# **RANCHO SANTIAGO COMMUNITY COLLEGE DISTRICT**

## **ADDENDUM NO. 03**

**Bid #1456 CAMPUS ENTRANCE IMPROVEMENTS PROJECT  
at  
SANTA ANA COLLEGE**

## DSA ADDENDUM NO: 01 & 02

ENLARGED IMPROVEMENTS SITE PLAN

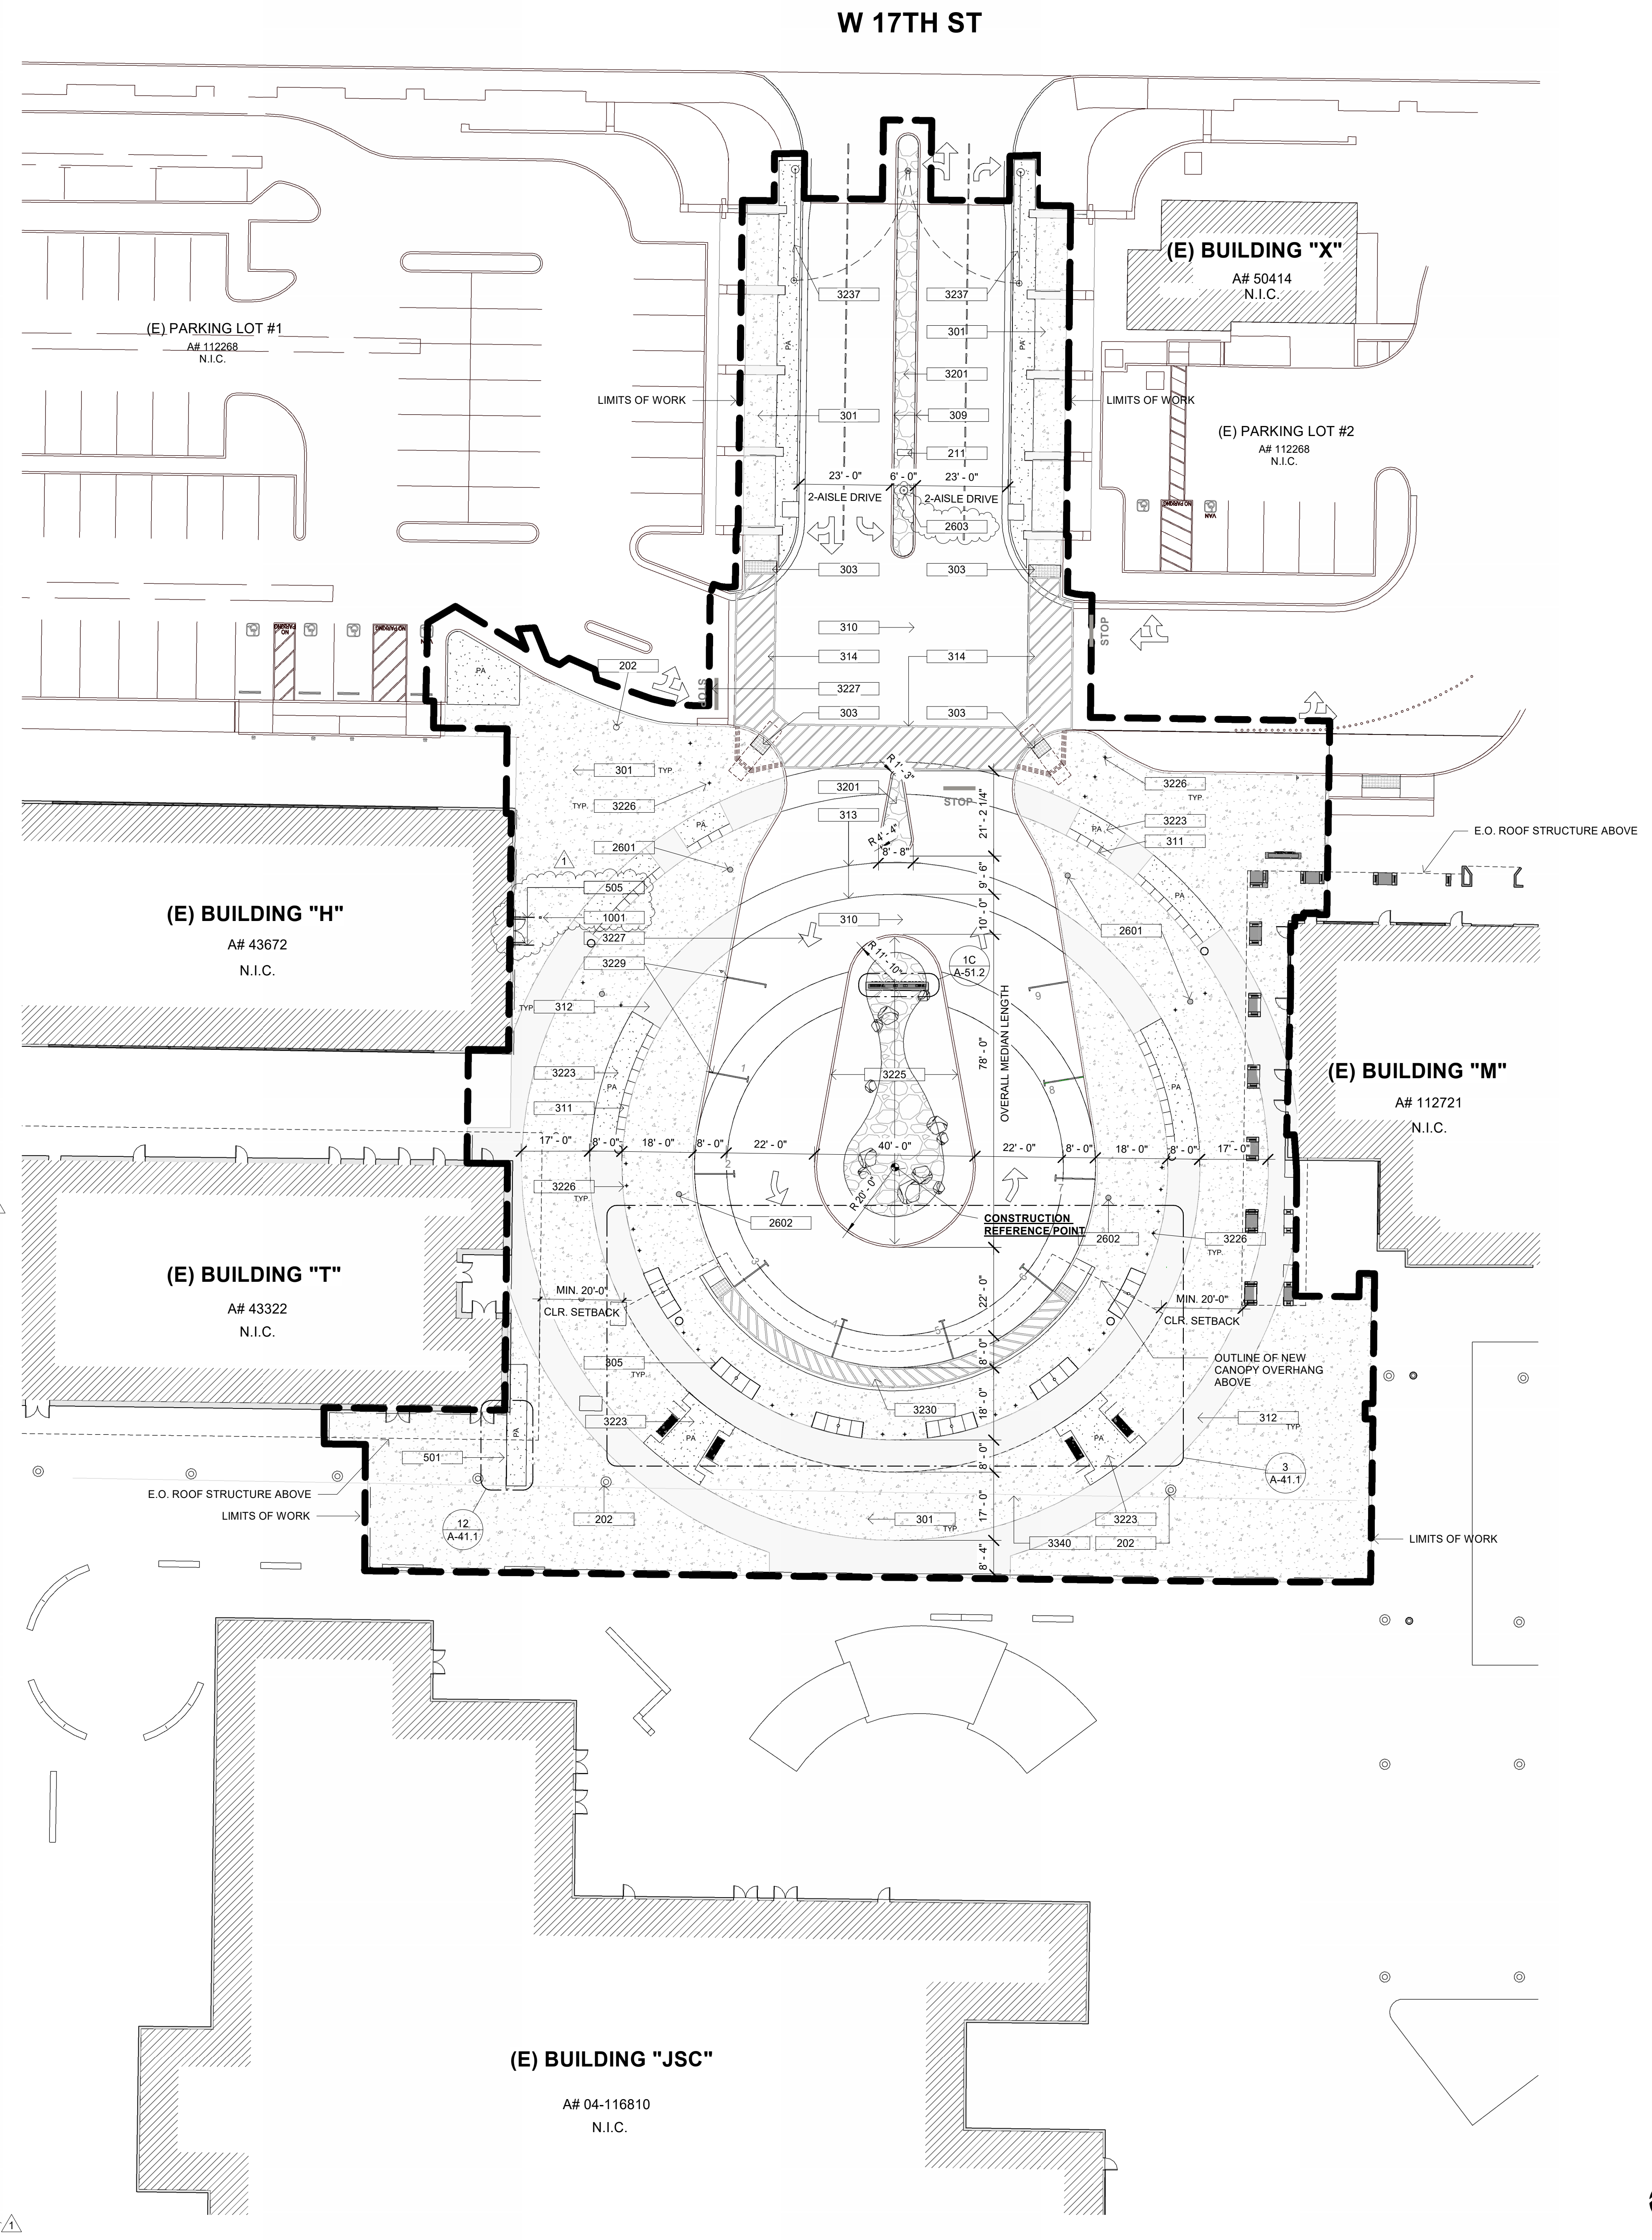
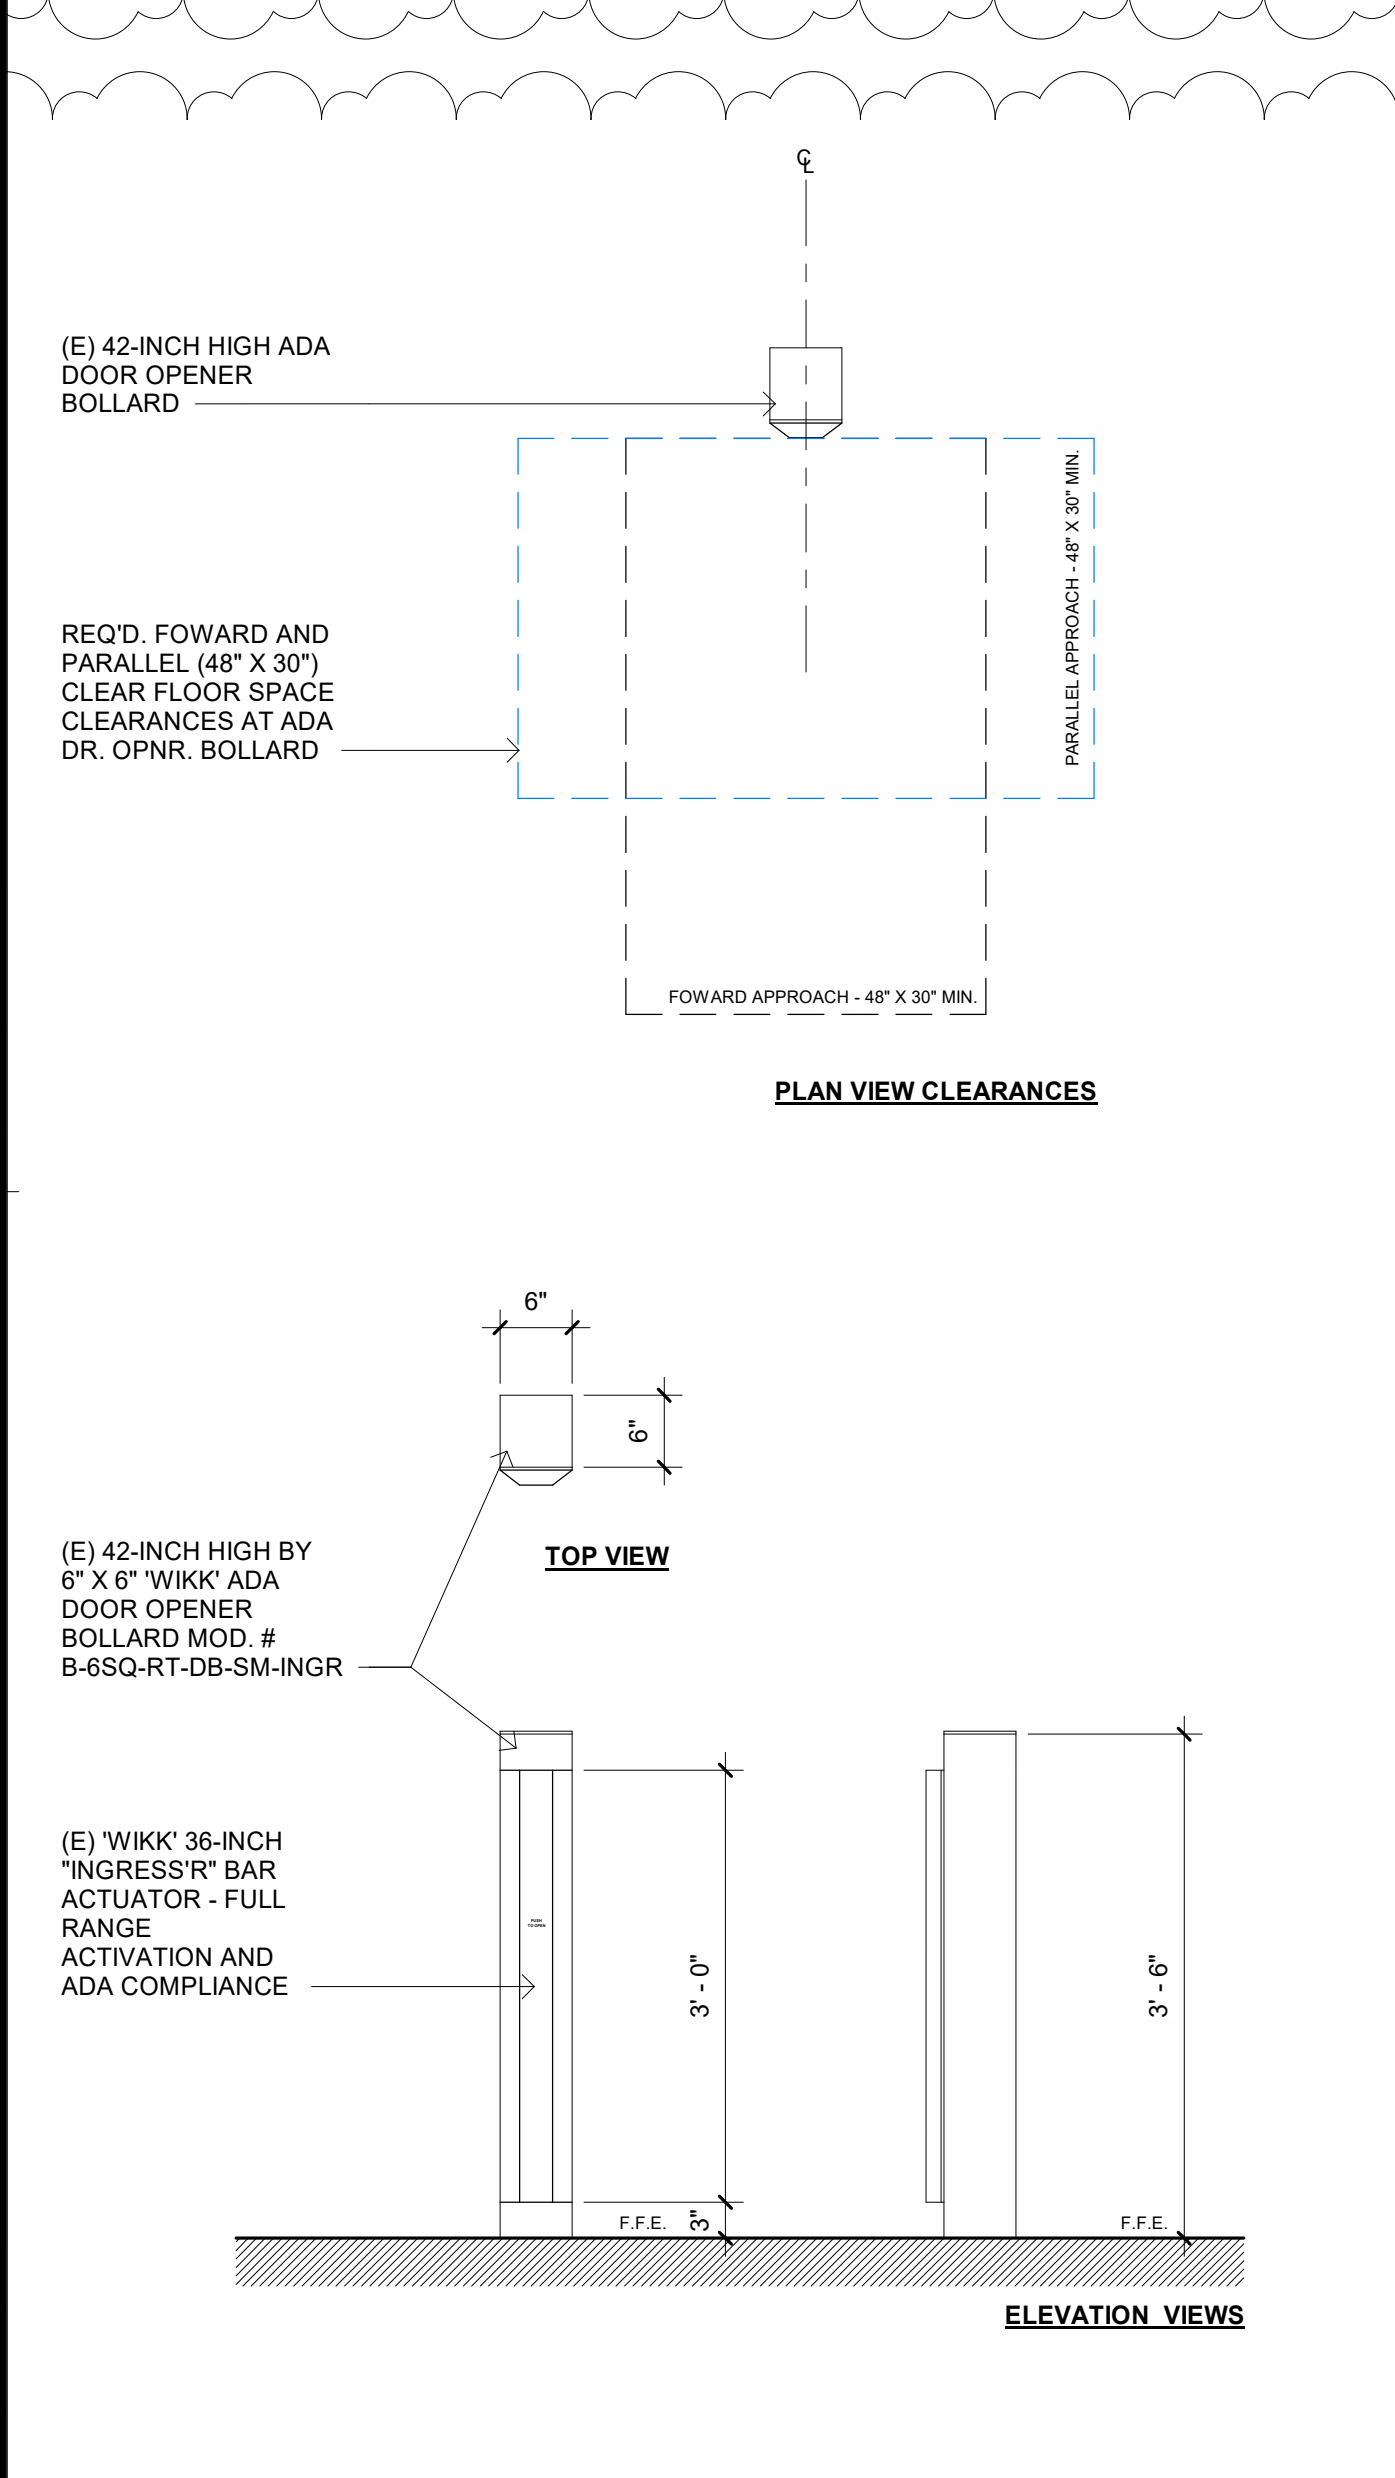
- A. A-11.1, Enlarged Improvements Site Plan: Added keynote #505, to indicate: *“reinstall salvaged existing exterior cane detection guide rail on each side of door at its original location – attach to (e) wall and (n) finish pavement. Refer to detail 3/A-11.1 for anchoring info.”* Added the keynote #505 on the site plan adjacent to Building “H” on the East.

- B. A-11.1, Enlarged Improvements Site Plan: Added detail 3 on the left side of the sheet, to provide information on anchoring the existing exterior cane detection guide rail that will need to be reused.

- C. A-11.1, Enlarged Improvements Site Plan: Added keynote #1001, to indicate: *“reinstall and attach existing ADA door opener bollard at its original location and adjust to new pavement grades – reconnect to existing electrical conduit. Refer to detail 2/A-11.1 for required height installation info.”* Added the keynote #1001 on the site plan adjacent to Building “H” on the East.

- D. A-11.1, Enlarged Improvements Site Plan: Added detail 2 on the left side of the sheet, per DSA’s request to illustrate the required height of the bollard.

- E. A-11.1, Enlarged Improvements Site Plan: Added keynote #2603, to indicate: *“reinstall and mount existing camera and pole onto new concrete foundation – refer to electrical drawings for mounting and new concrete foundation base detail.”* Added the keynote #2603 on site plan within the new center median at the drive aisle, including located the camera pole’s concrete base.
